Minutes of the Reorganization Meeting of the Haverford Township Planning Commission held on Thursday, January 9, 2020 at 7:00 p.m. in the Commissioners' Meeting Room, 1014 Darby Road, Havertown, Pa. 19083.

Item # 1 Sleepy Valley Holdings, LLC. Greenbriar Lane –DC Folio No. 22-09-01348-00 Review of preliminary/final minor subdivision plan

Preliminary/Final Minor Subdivision Plan 1613 Pelham Avenue- D.C. Folio No. 22-06-01738-00

RECORD PLAN 1613 PELHAM AVENUE, HAVERFORD TOWNSHIP DELAWARE COUNTY PENNSYLVANIA DRAWN BY: PROJ. NO.:

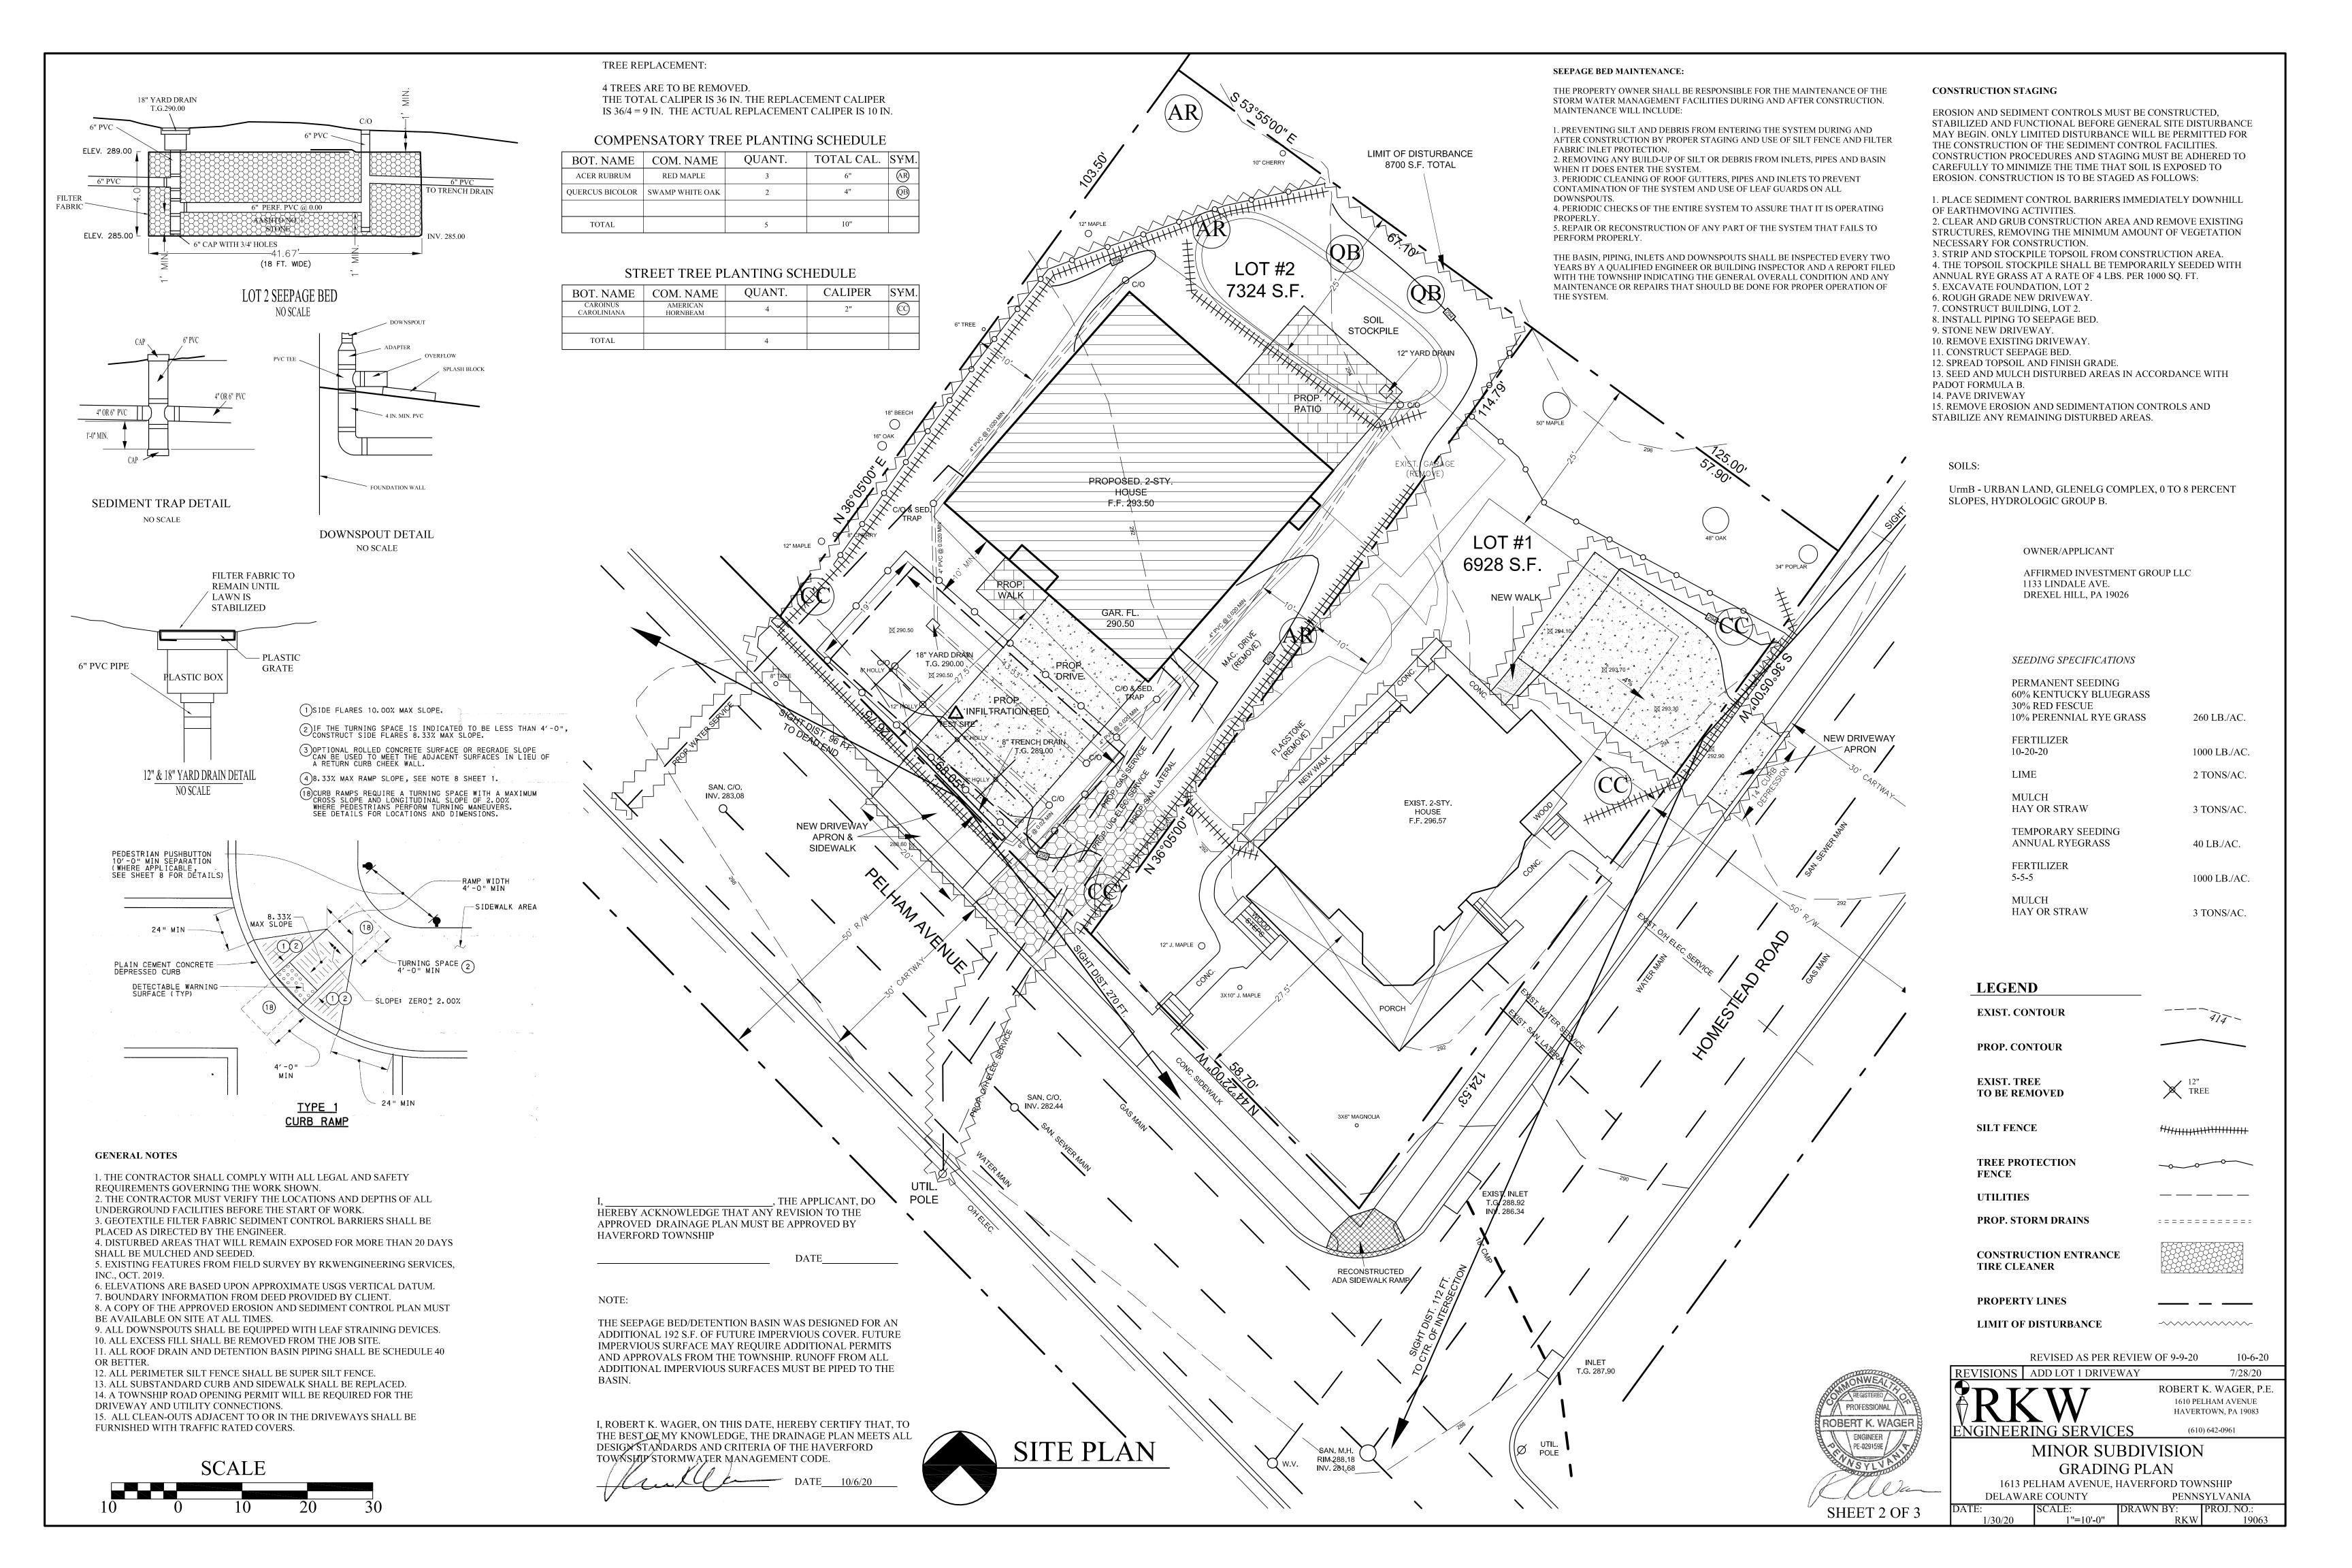
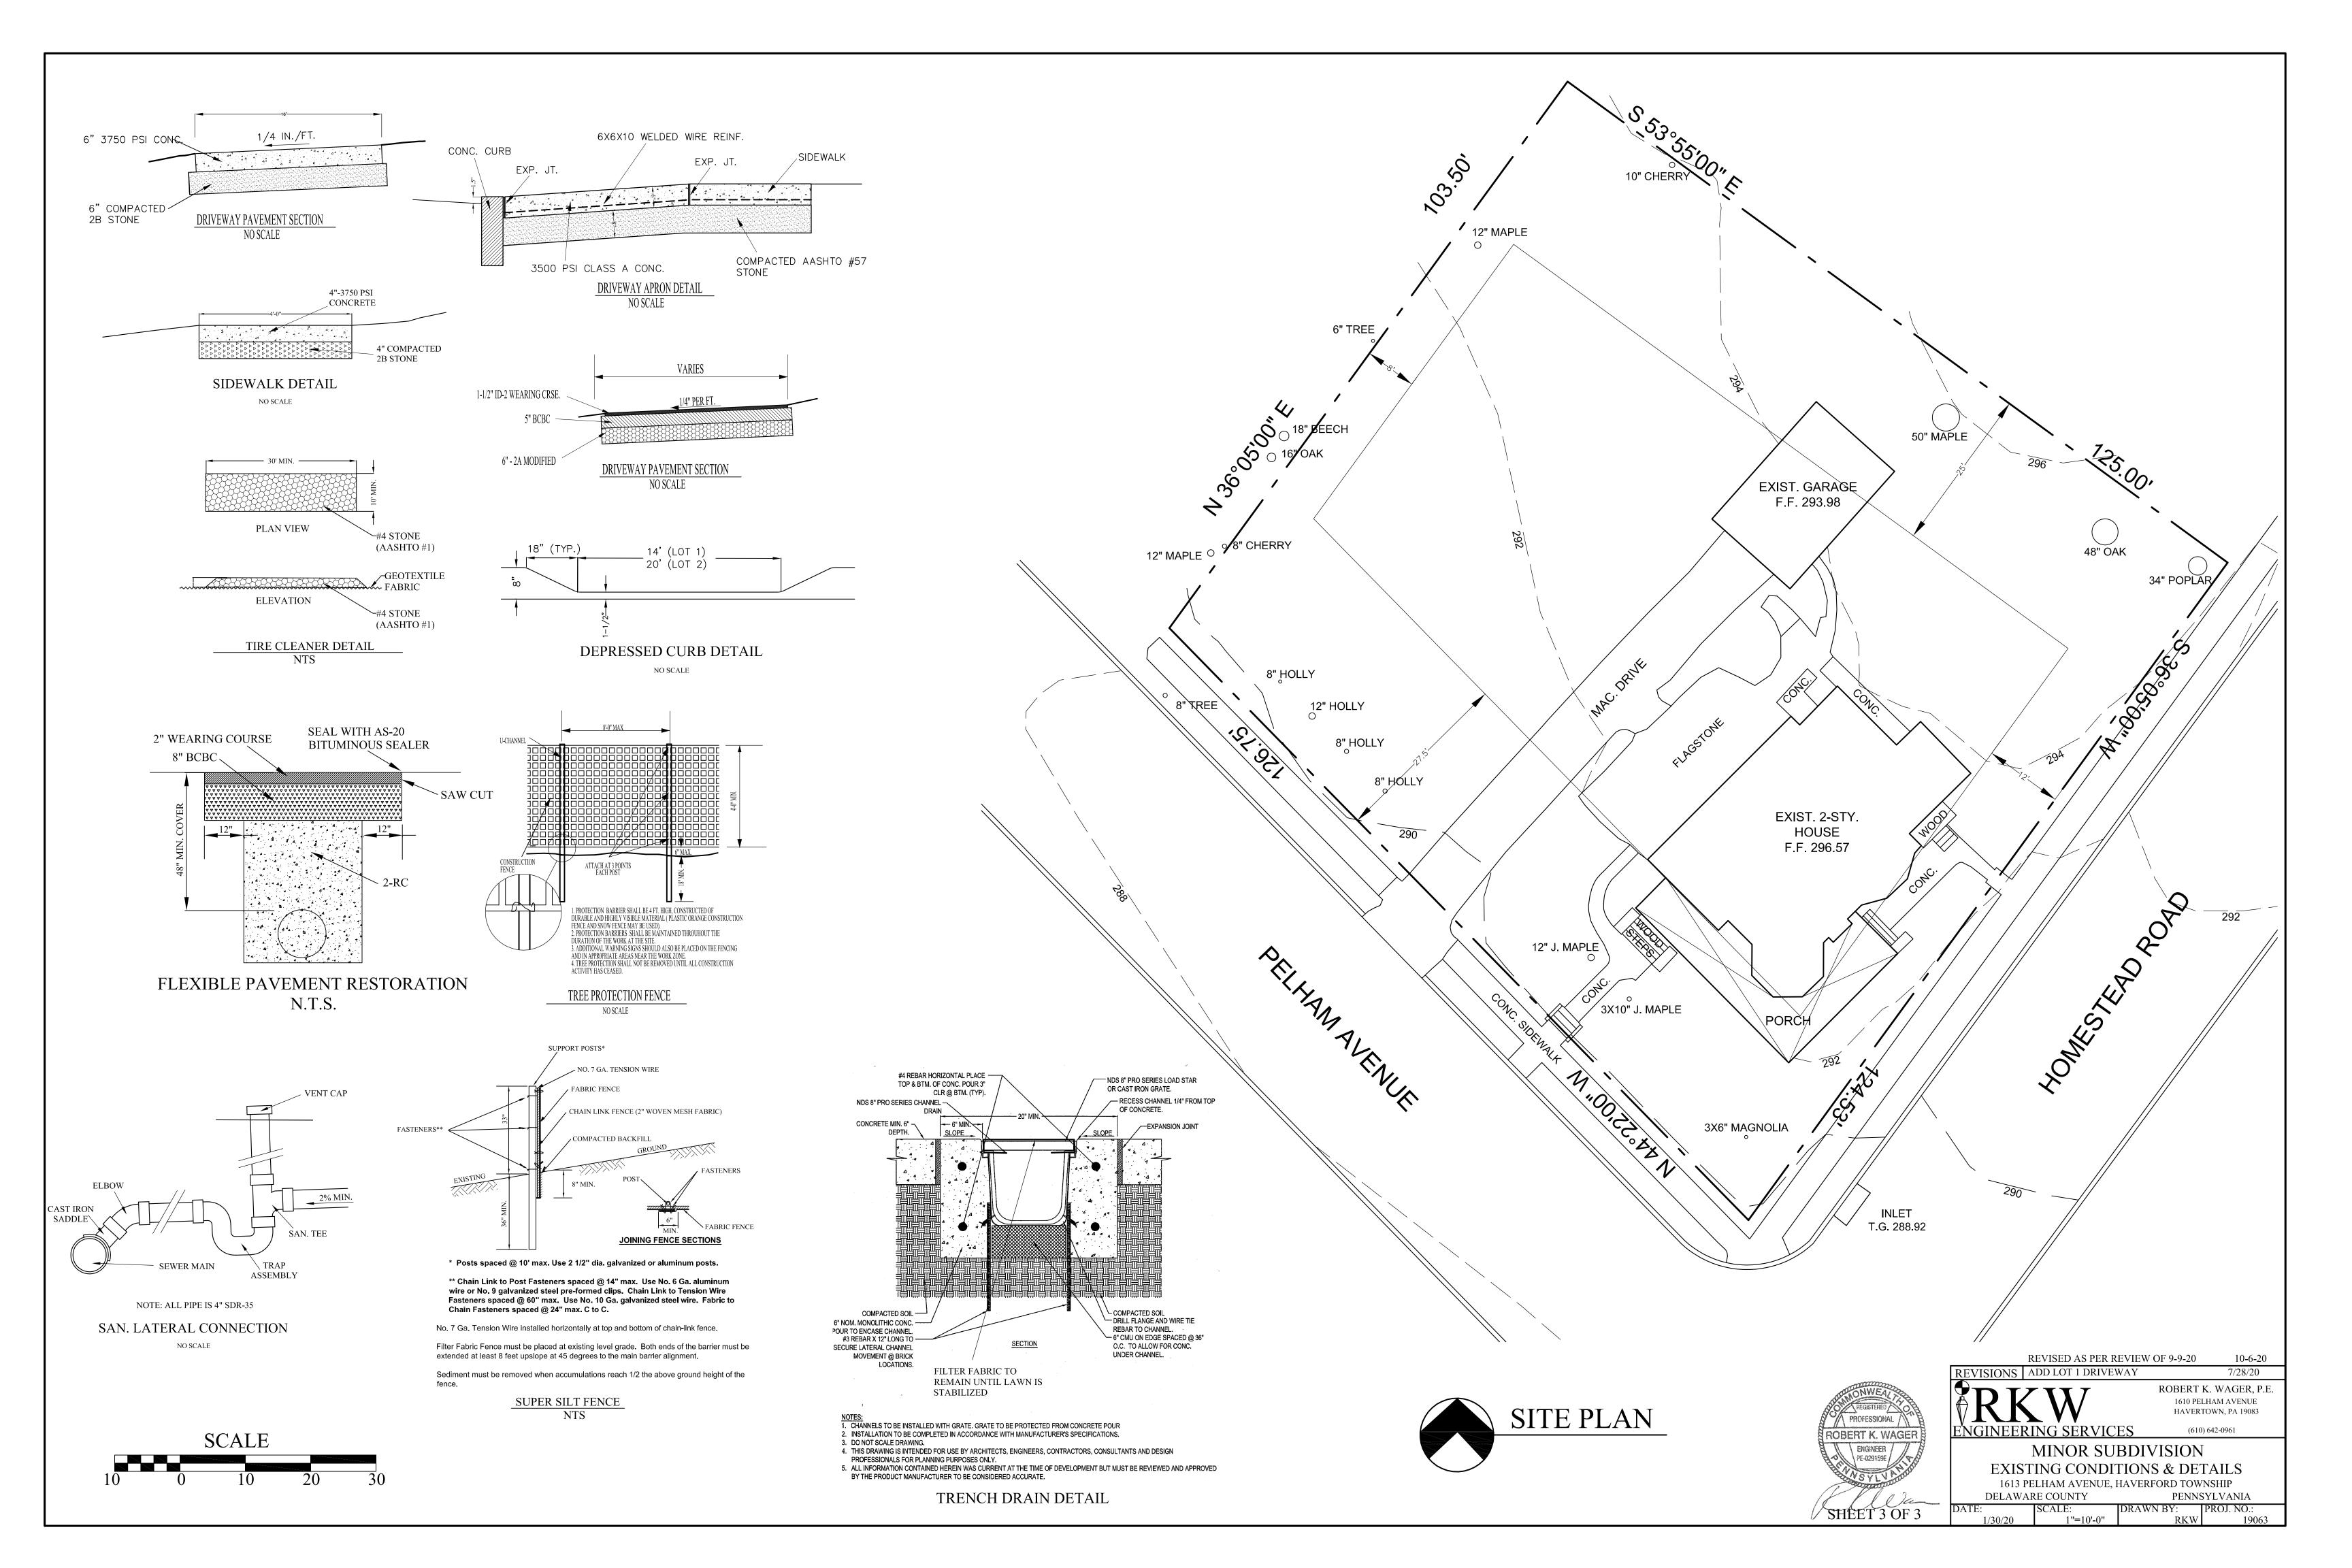
Mr. Capuzzi offered technical comments starting with Sheet 2, the grading plan. The sanitary lateral needs to have a clean out added at the bend in the line; add detail. The Contour at the back left of the house needs the correct elevation designation. Mr. Capuzzi suggested an arborist look at the trees on Lot 1 to offer their input on the impact to the viability of the trees relative to the grading proposed within their drip lines. Mr. Capuzzi added that the seepage bed detail needs to have exact dimensions and the observation port should go to the bottom of the bed and the pipes within the seepage bed should be interconnected so that the collected runoff would be more evenly distributed throughout the seepage bed.
